UNITED STATES PATENT AND TRADEMARK OFFICE

APPLICATION NO.	FILING DATE	FIRST NAMED INVENTOR	ATTORNEY DOCKET NO.	CONFIRMATION NO.
09/917,749	07/31/2001	Yasutaka Ito	110575.01	2777

Office Action Summary

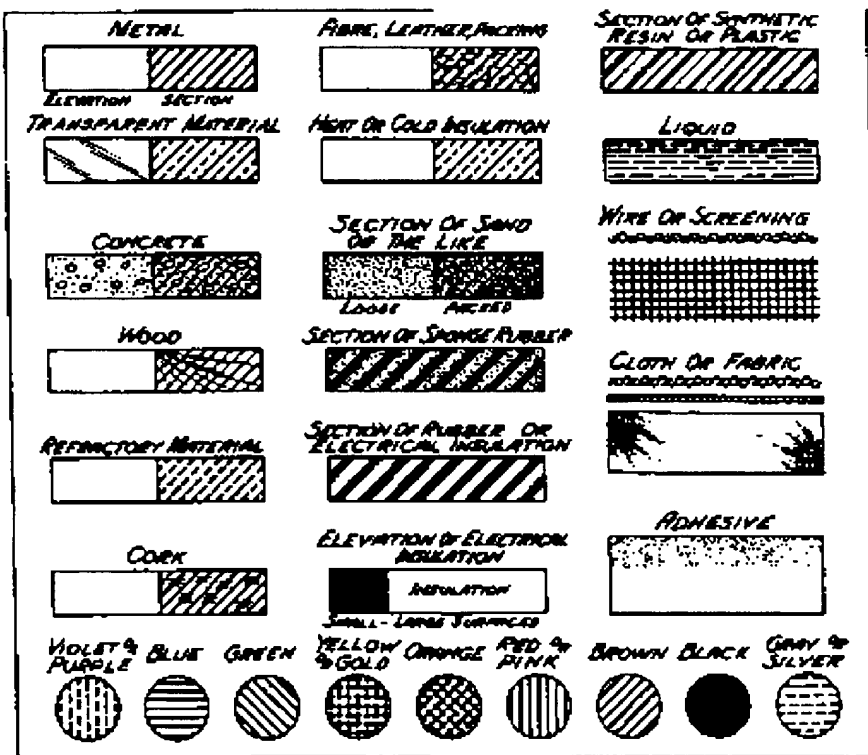
Figs. 1-3, 5, 7-11, 13: Proper cross-sectional hatching is required to properly denote insulative materials in accordance with MPEP 608.02 (see the drawing below for proper hatching examples).

The response to this action must include a separate letter addressed to the examiner and contain: (1) sketches showing in red the drawing changes required above and (2) a request that the examiner approve the changes as shown on the sketches.
